MONTGOMERY COUNTY HISTORIC PRESERVATION COMMISSION
STAFF REPORT

Address:	7204 Cedar Ave., Takoma Park	Meeting Date:	2/21/2018
Resource:	Outstanding Resource (Takoma Park Historic District)	Report Date:	2/14/2018
Applicant:	Nancy Augustine and Adam Oppenheim (Jackie Braitman, Architect)	Public Notice:	2/7/2018
Review:	HAWP	Tax Credit:	No
Case Number:	37/03-18J	Staff:	Michael Kyne
PROPOSAL:	Building addition

PROPOSED SITE PLAN - 1 in = 30 ft
HAWP APPLICATION

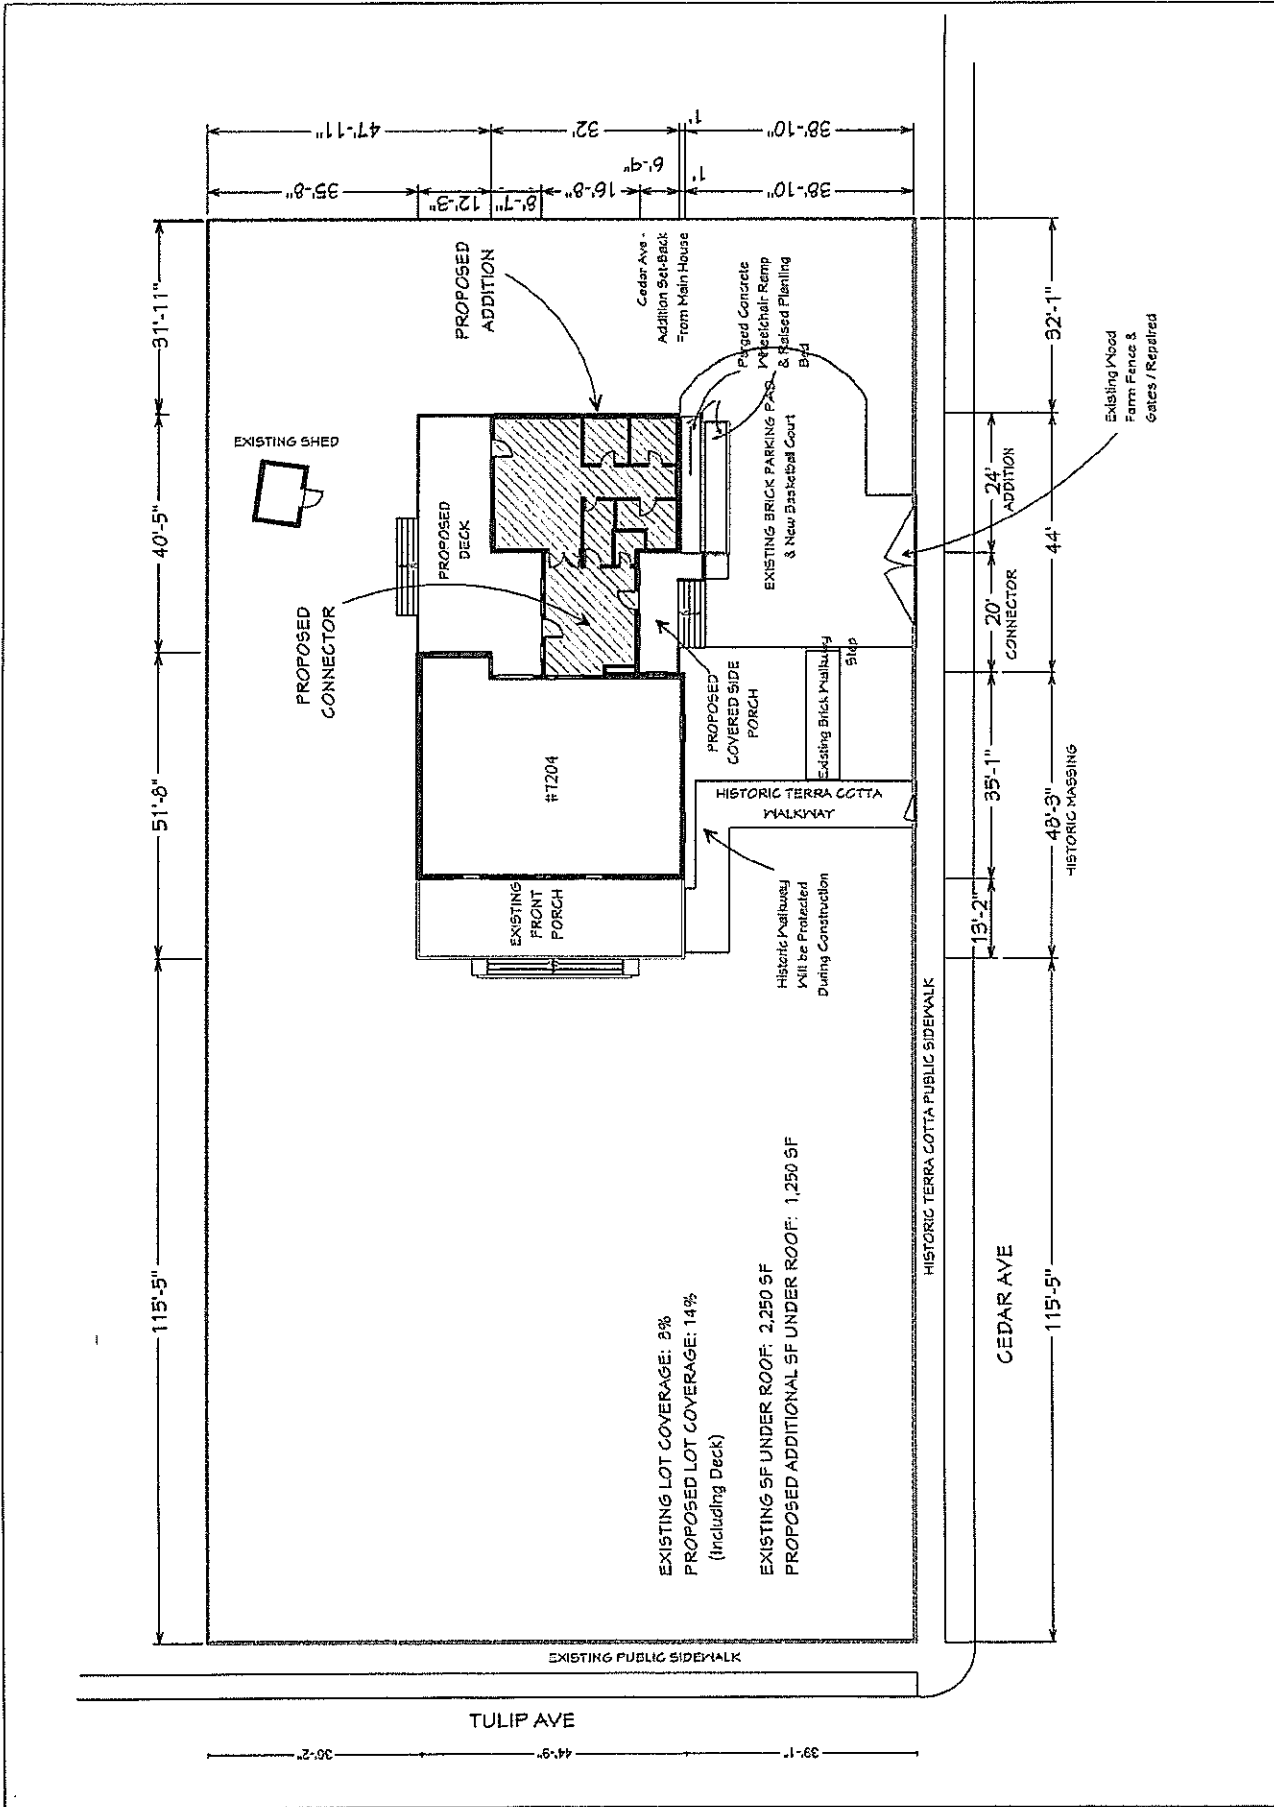
19 And this was not in the Staff Report, but it has
20 come to Staff's attention that this property may be in a
21 sensitive area as the existing terracotta sidewalks along
22 Cedar Avenue are the only remaining original sidewalks in
23 the historic district. The City of Takoma Park is actively
24 working with Historic Takoma to formulate a plan to protect
25 these sidewalks. From the submitted site plan it is unclear

1 how the existing rear paver driveway is proposed to be
2 altered, and whether these alterations have the potential to
3 impact the adjacent sidewalks. Staff asks the applicant to
4 clarify the proposal so that the Commission can ensure that
5 the sidewalks will not be damaged. And, Staff also notes
6 that there is an existing terracotta walkway. You saw that
7 in the photos at the right side of the house. The walkway
8 shares characteristics with the sidewalks along Cedar
9 Avenue, but it's unclear if it is original and/or if it is
10 proposed to be altered. Any information that can be
11 provided regarding the walkway, and whether it is original,
12 will help the Commission make informed recommendations.

3 MS. BRAITMAN: Jackie Braitman, Braitman Design
4 Studio. I'm an agent for the owners. The answer to your
5 question is that that chain link has been on for a very long
6 time. The owners, current owner is the estate of the
7 Augustines, and the heir is their daughter, who is my
8 client. The Augustines have owned the house for 65 years,
9 and Nancy, the daughter, the current owner, or to be owned,
10 the heir, is very interested in restoring the house and
11 preserving its character. The terracotta walkway is not
12 being impacted. The existing terracotta walkway on the
13 property, so the -- this is brick, and not historic. This
14 is terracotta and is the same terracotta as the sidewalk
15 that is in the, on Cedar Avenue. There's no work that we
16 would be proposing that would impact the terracotta.

12 MS. BRAITMAN: The plan was, is to, in the same
13 way that we would do a tree protection plan, we would do a
14 plan to protect those pavers on the lot, and also the pavers
15 that we would be crossing as we bring construction equipment
16 into the site. They actually are in pretty good, the
17 sidewalk on the property is in quite good shape, and my
18 worry would be that in uninstalling them, we would damage.
19 them. And so, my current plan would be to protect them
20 rather than to uninstall them and reinstall them.

E2 - PROPOSED BACK ELEVATION
3/32 in = 1 ft

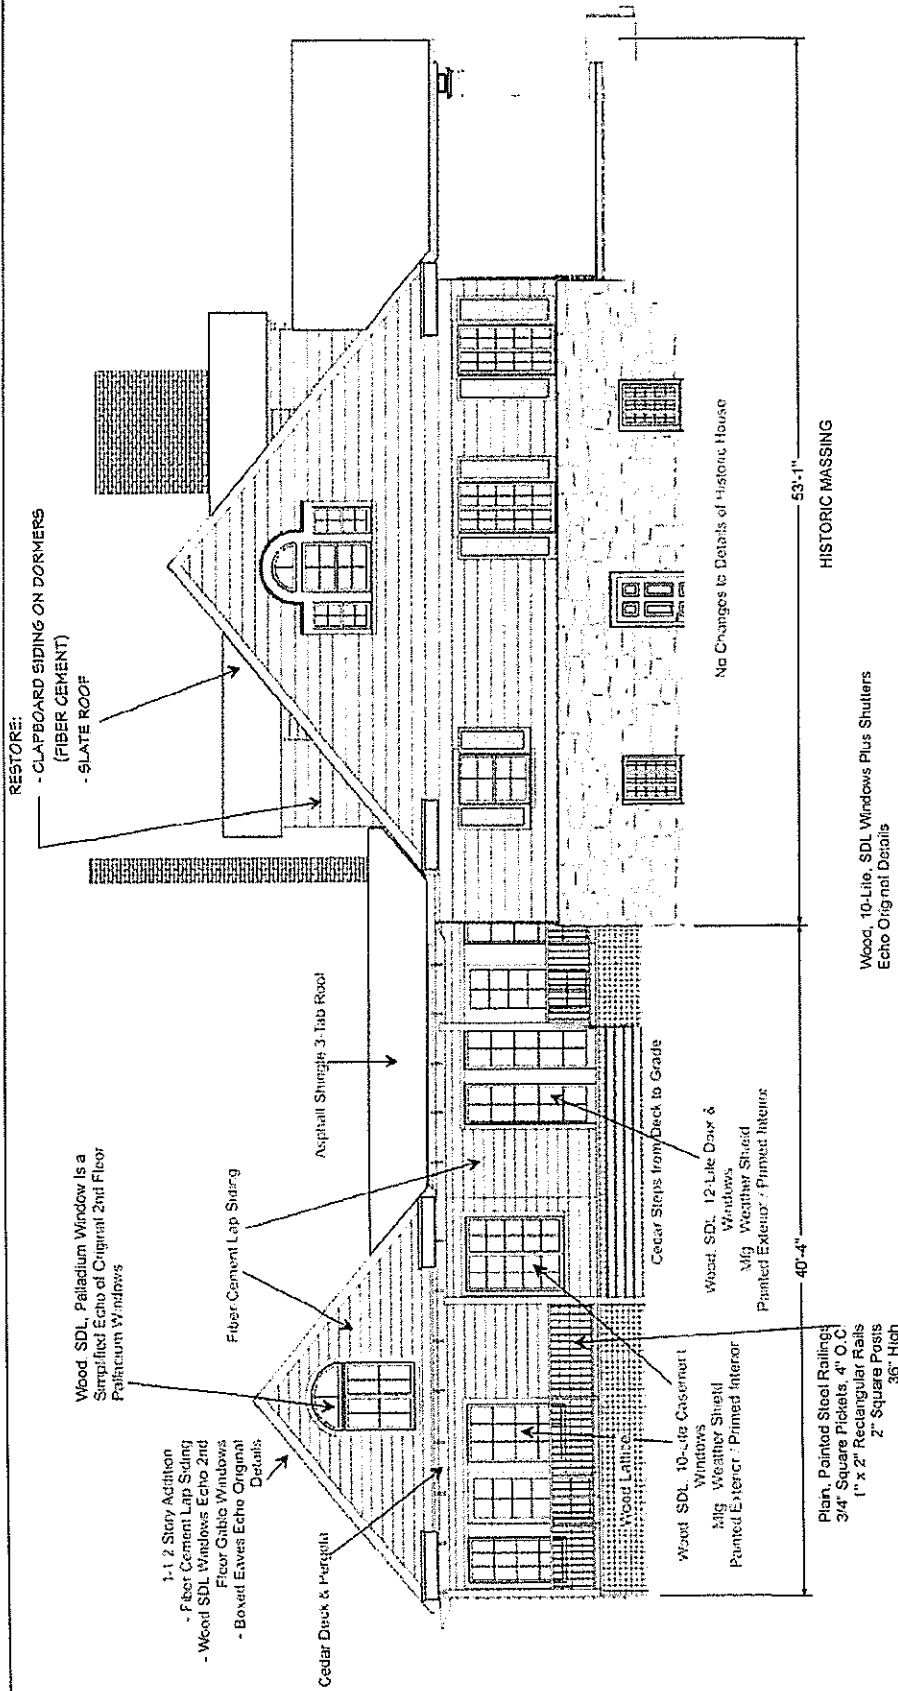
- The hyphen approach is appropriate, but some steps should be taken to make it read more as a

hyphen and/or distinct space. This could be accomplished by adding more fenestration, or perhaps by simply swapping the previously proposed right and left elevations of the hyphen.

- If possible, the hyphen should be shortened, while retaining the view of the dormers and other character-defining features on the rear of the historic house.

- The standing seam metal roof could be appropriate, if the correct details and finish (no ridge caps or vents, appropriate seam height, and a paintable matte finish) are proposed.

- The proposed curvilinear wheelchair ramp should be straight and moved adjacent to the building.
- The proposed poured concrete foundations and ramp should be parged to be more consistent with the historic house's foundation.

- More fenestration has been added to the proposed hyphen, with 12-lite doors and windows added to the left and right elevations.
- The length of the proposed hyphen has been reduced, going from 25'-11" to 20'.
- Asphalt shingle roofing is proposed for the hyphen and rear addition, differentiating the new structures from the historic house with slate roof.
- As revised, the wheelchair ramp is straight and directly adjacent to the proposed rear addition.
- The proposed wheelchair ramp will be parged to be consistent with the painted stone foundation of the historic house.
- The Palladian windows on the side elevations of the proposed rear addition have been simplified to take cues from but not replicate the details of the historic house.
